PISD 2023 HVAC and Control System Renovations Post-Installation Addendum October 29, 2024

KELLY LANE MIDDLE
SCHOOL HVAC AND
CONTROL SYSTEM
REPLACEMENT

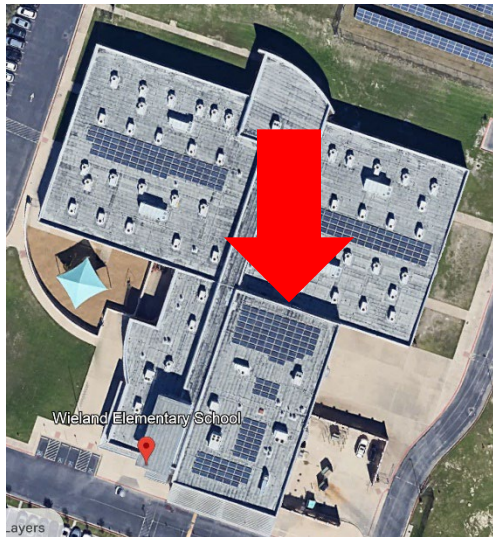
Where is the solar panel interface?

Answer: On wall at roof level, per picture.

A ROOF PLAN, AREA G
SCALE: 1/8" = 1'-0"

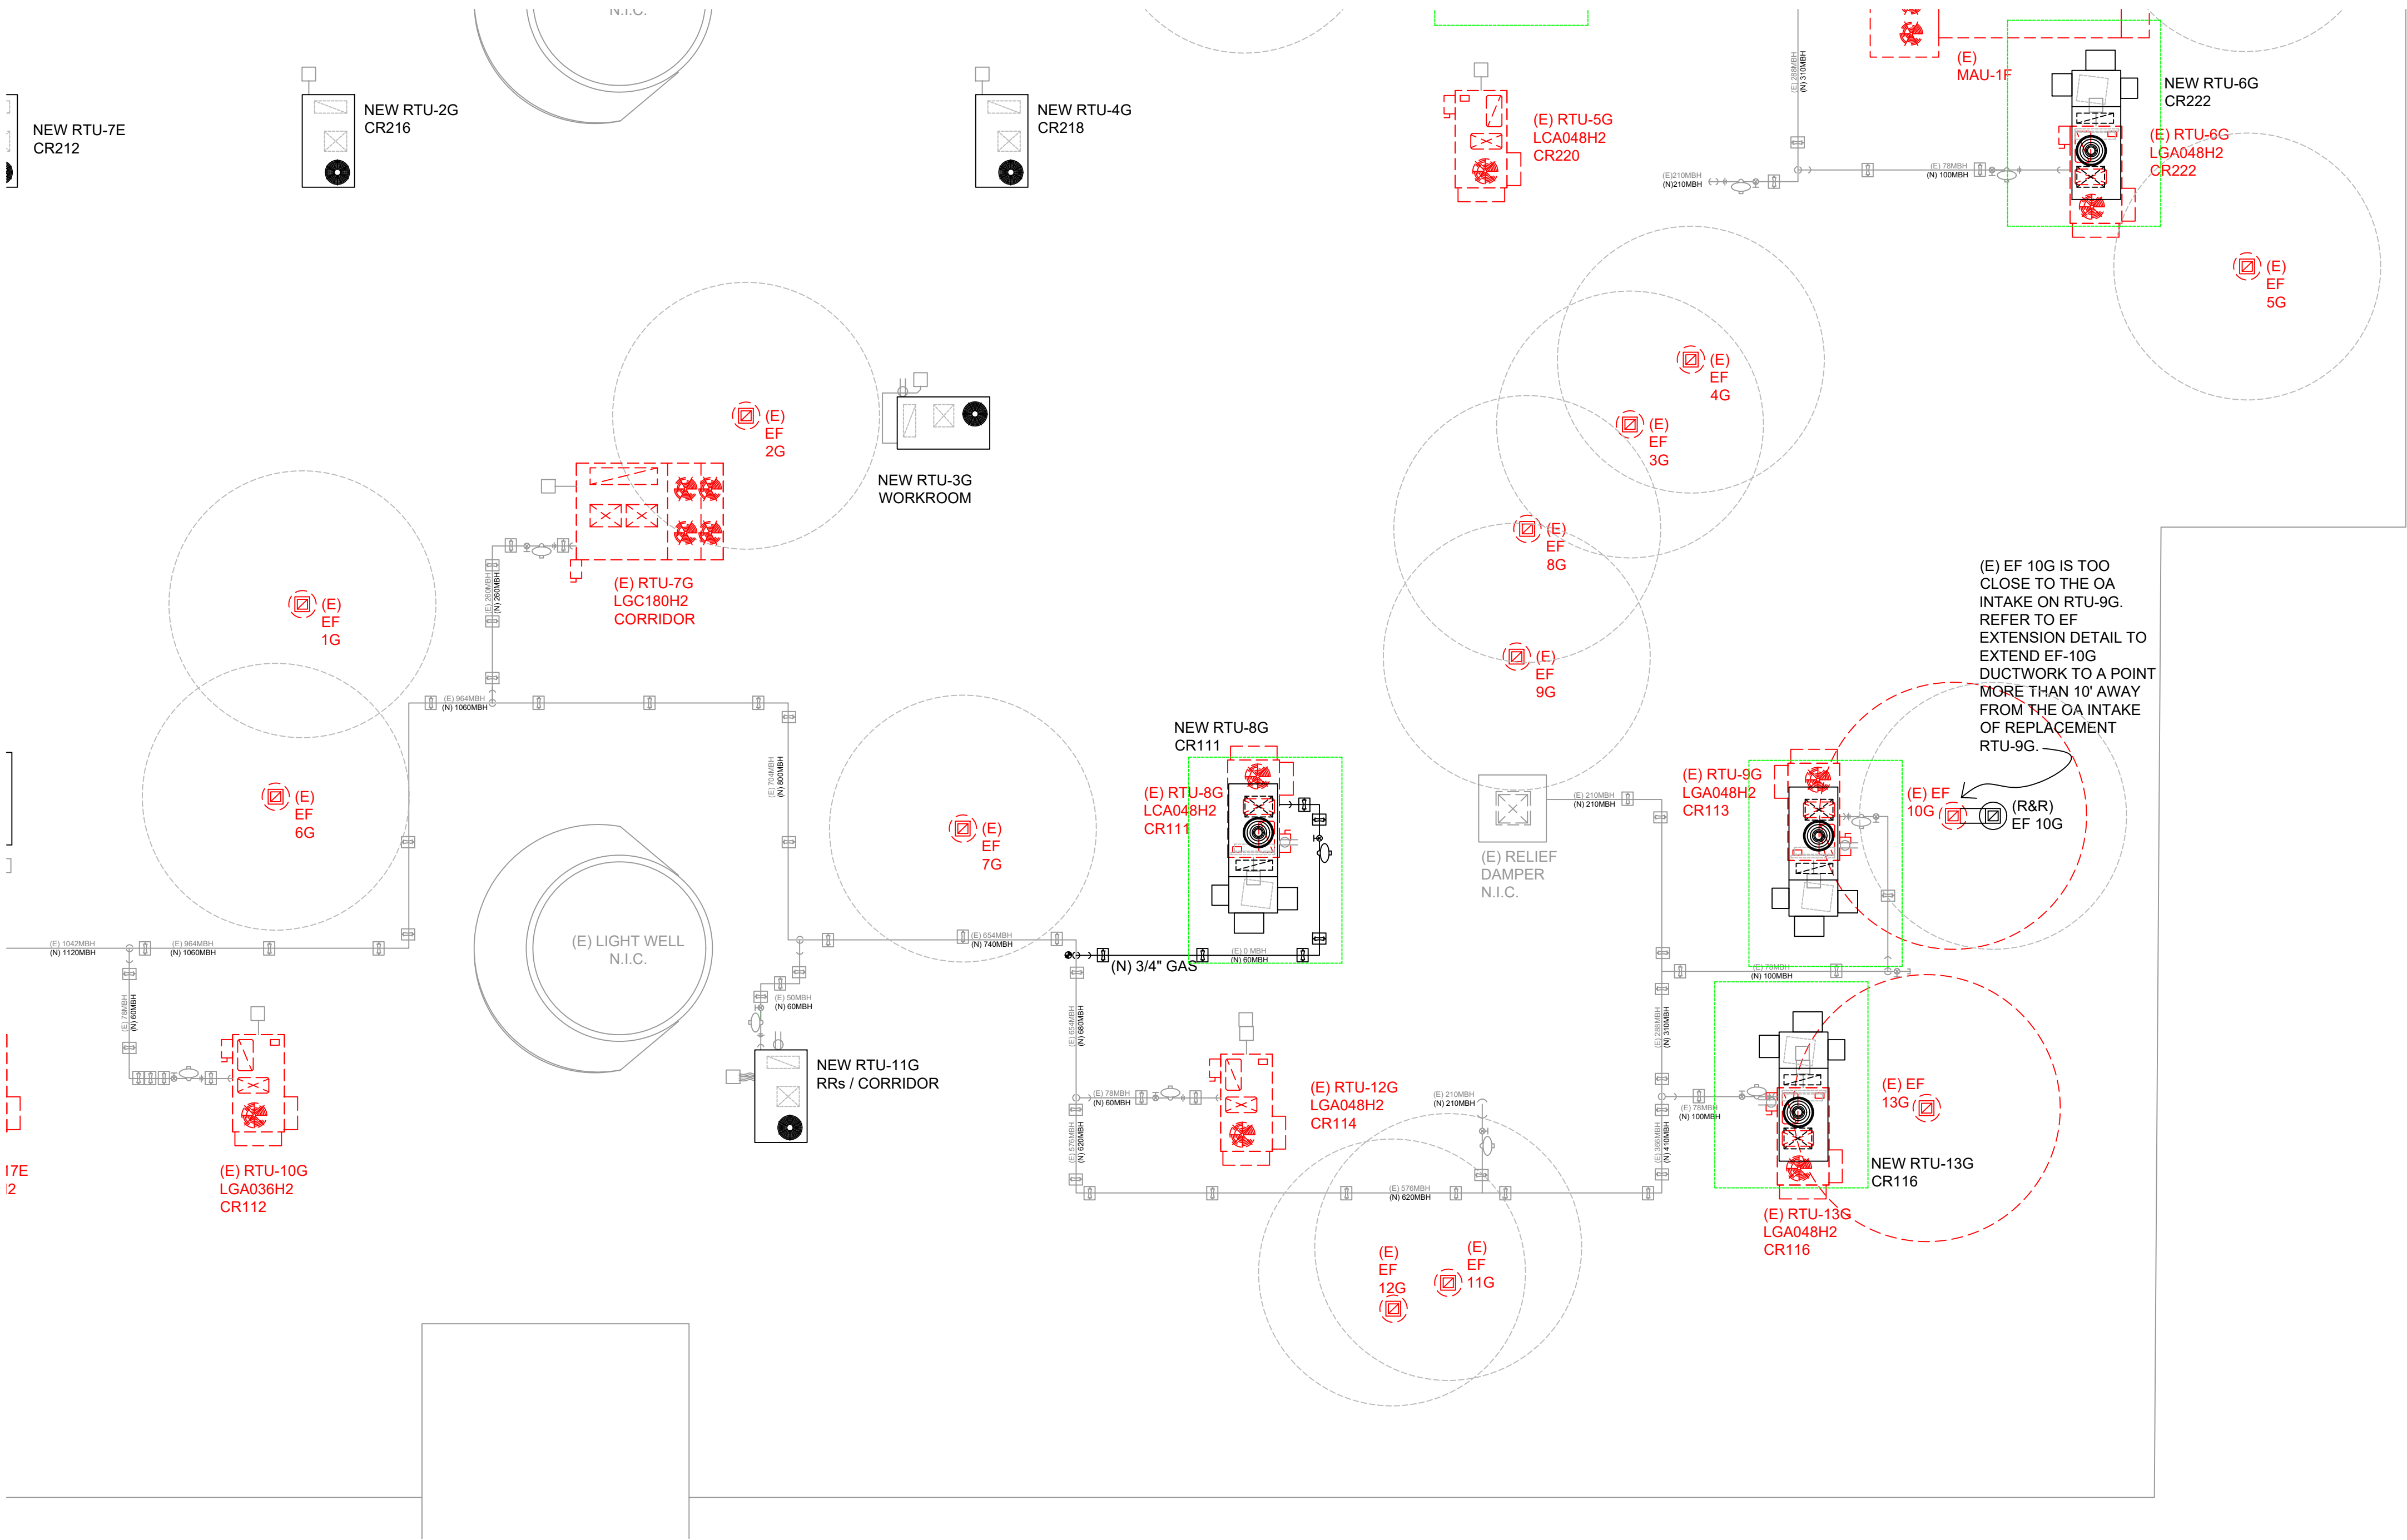
ITEM #19, ADDENDUM #1, 10.29.2024
NEW DRAWING SHOWING NEW SCIENCE
ROOM RTU FOOTPRINTS OVER EXISTING
RTU FOOTPRINTS.

1. There are two (2) new drawings showing the footprint of the new RTU over the footprint of the old. On drawings MEP 1.9.0, 1.10.0, and 1.11.0:
 - a. the dashed red lines are the existing unit footprint.
 - b. The green dashed lines are the service clearance requirements of the new RTUs.
 - c. The white lines are the footprint of the new RTU.
2. Exhaust Fan 13G will no longer require relocation away from new RTU-13G; the additional length of the unit has moved the OA intake farther than 10' from the RTU.
3. Exhaust Fan 10F will no longer require relocation away from new RTU-10F; the additional length of the unit has moved the OA intake farther than 10' from the RTU.
